Attachment 1 - PLN20/0747 - 1-13 Oxford Street, Collingwood - Decision Plans (advertised)

Attachment 2 - PLN20/0747 - 1-13 Oxford Street, Collingwood - Without Prejudice Sketch Plans and WMP (2 June 2021)

Referral Response by Yarra City Council

Responsible Planner:	Michelle King
ESD Advisor:	Gavin Ashley
Date:	14.04.2021
Subject Site:	PLN20/0747 1-13 Oxford Street, Collingwood VIC 3066
Site Area:	Approx. 838 m ²
Project Description:	Seven storey office building, with rooftop terrace.
Pre-application meeting(s):	Unknown.
Documents Reviewed:	<ul style="list-style-type: none"> • Sustainability Management Plan (Rev 3 – 10.12.20) by ARUP • Architectural Plans (TP4 – 19.02.21) by Kerstin Thompson Architects • Green Travel Plan (16.12.20) by One Mile Grid • Waste Management Plan (16.12.20) by One Mile Grid • Landscape Plan (TP1 – 16.12.20) by Simon Ellis Landscape Architects

ENLARGED OXFORD STREET ENTRY PLAN
KTA
21/05/2021

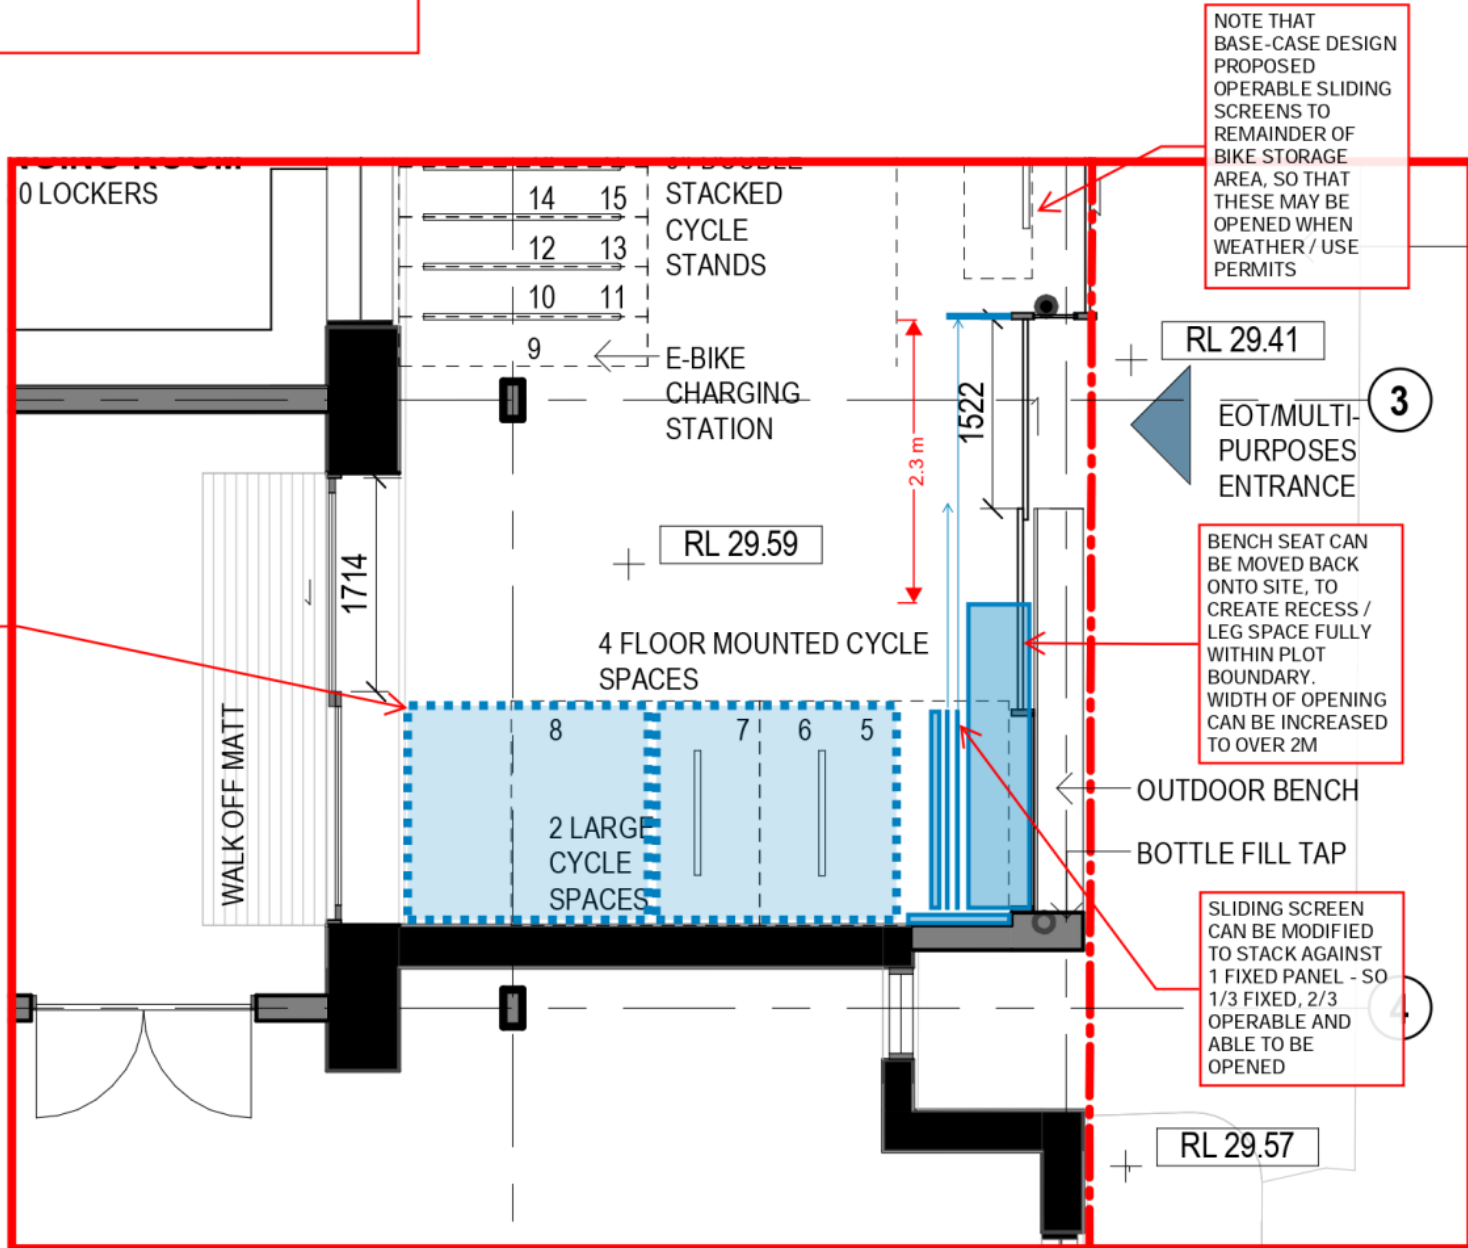
RELOCATE LARGE & FLOOR-MOUNTED CYCLE SPACES LEFT, TOWARDS THE ENTRY DOOR. THIS CAN CREATE MORE ROOM AT STREET FOR ENTRY / BENCH SEAT

NOTE THAT BASE-CASE DESIGN PROPOSED OPERABLE SLIDING SCREENS TO REMAINDER OF BIKE STORAGE AREA, SO THAT THESE MAY BE OPENED WHEN WEATHER / USE PERMITS

SLIDING SCREEN CAN BE MODIFIED TO STACK AGAINST 1 FIXED PANEL - SO 1/3 FIXED, 2/3 OPERABLE AND ABLE TO BE OPENED

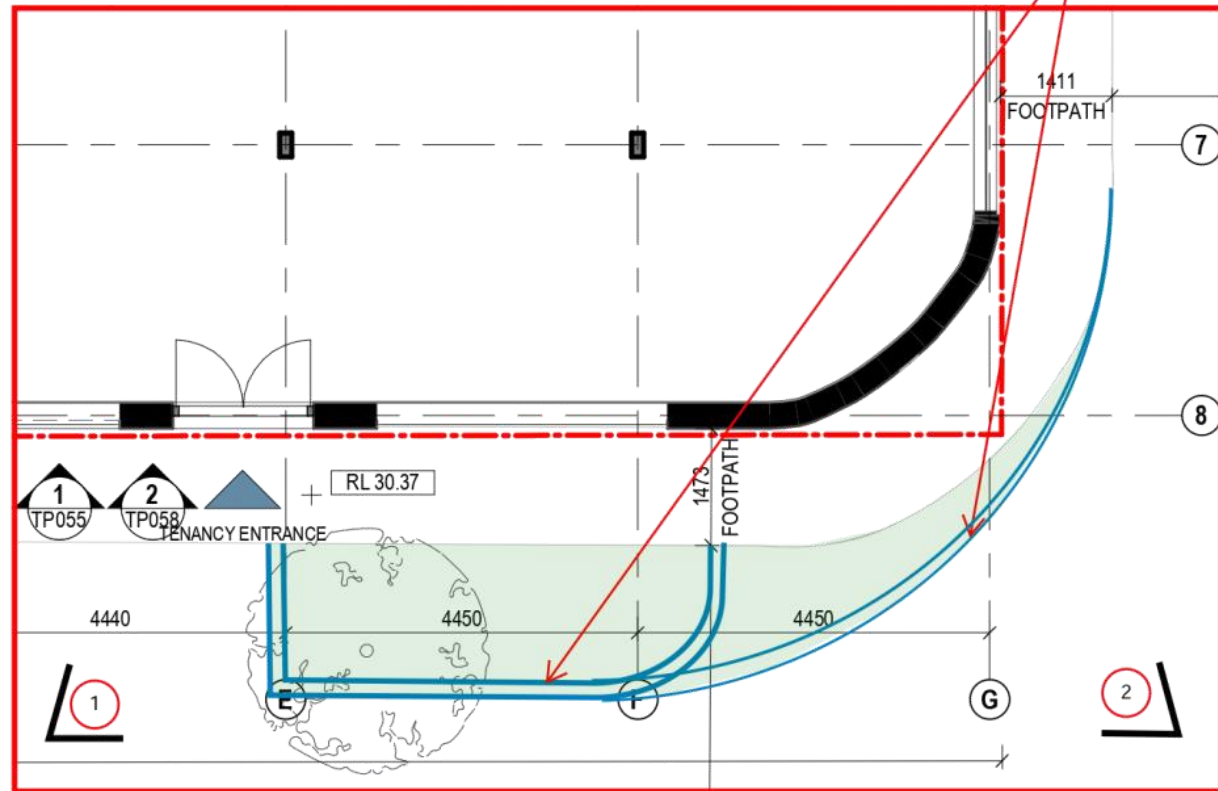
ESTIMATED AREA OF PROPOSED LANDSCAPE AREA IN CURRENT NO STANDING ZONE. EXACT CONFIGURATION TO BE CONFIRMED WITH TRAFFIC ENGINEER'S SWEEP-PATH ANALYSIS
